Environmental Protection Act 1986

Section 43A

**NOTICE OF DECISION TO CONSENT TO CHANGE TO
PROPOSAL DURING ASSESSMENT**

Ashburton Salt Project – Assessment No. 2101

Figure 1:
Ashburton Salt Project
Location

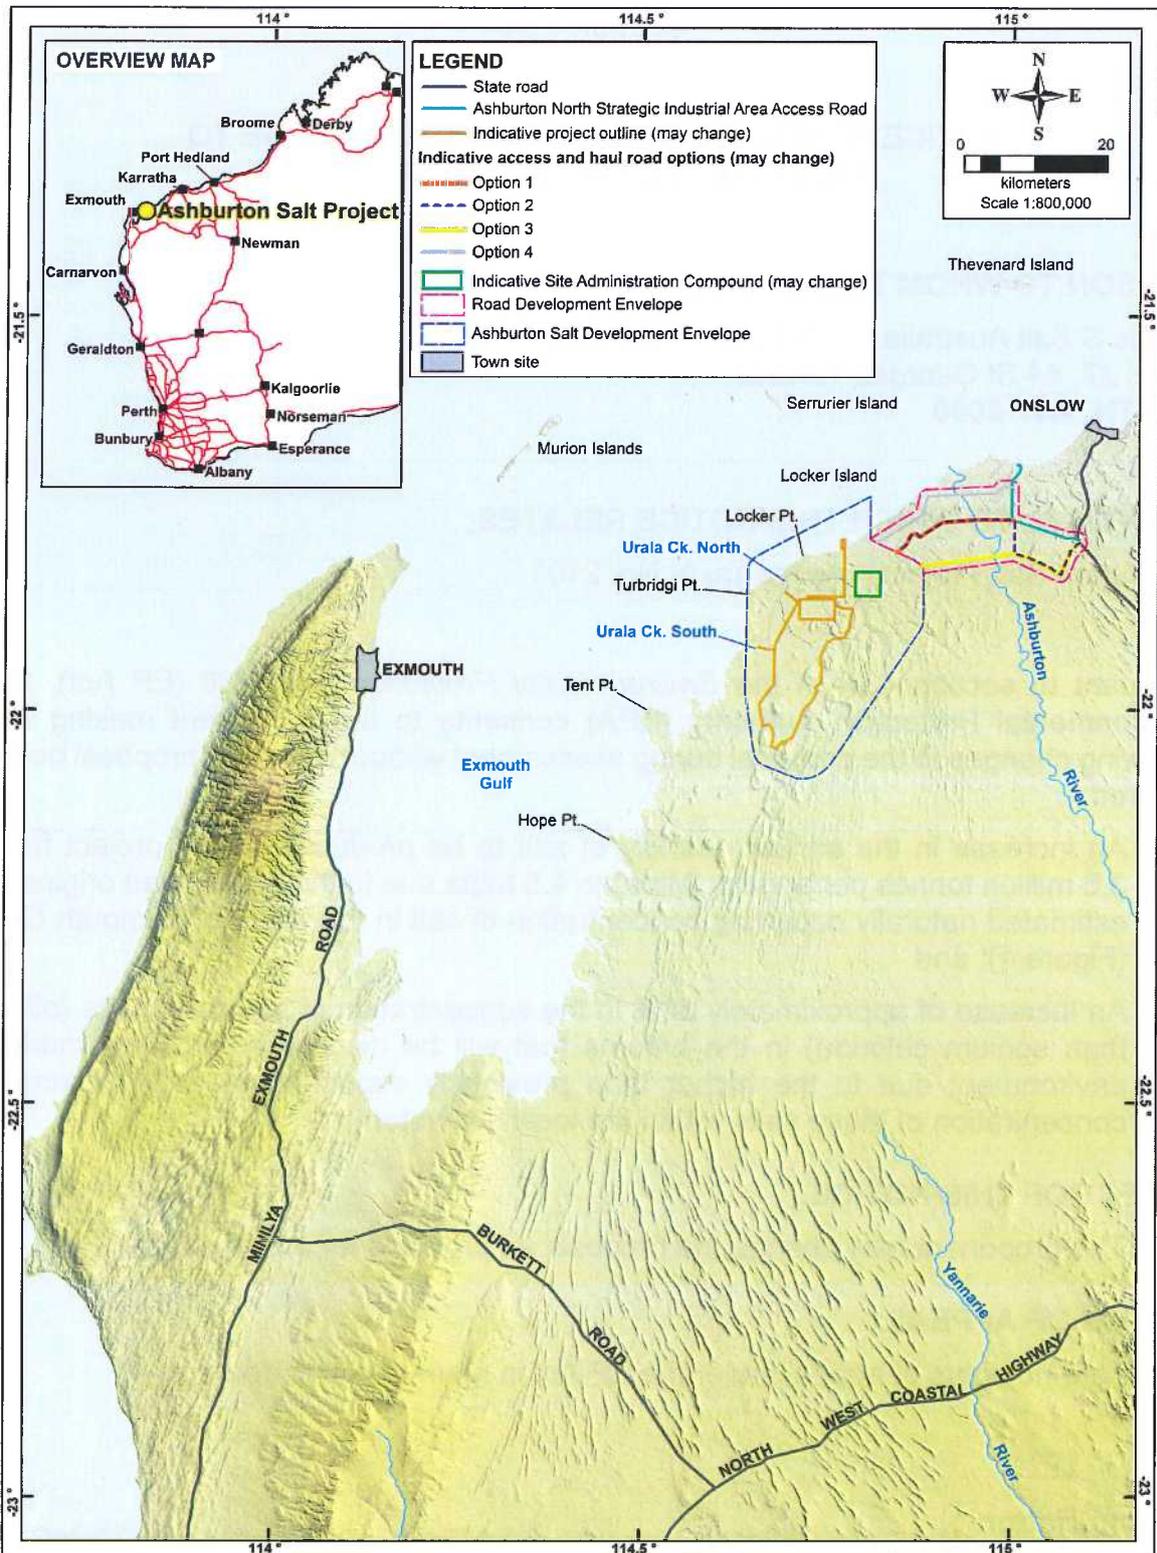
1. An increase in the annual quantity of salt to be produced by the project from 3.5 million tonnes per annum (Mtpa) to 4.5 Mtpa due to the higher than originally estimated naturally occurring concentration of salt in the water of Exmouth Gulf (Figure 1); and
2. An increase of approximately 30% in the concentration of seawater salts (other than sodium chloride) in the bitterns that will be discharged into the marine environment due to the higher than previously expected naturally occurring concentration of these salts within the local seawater.
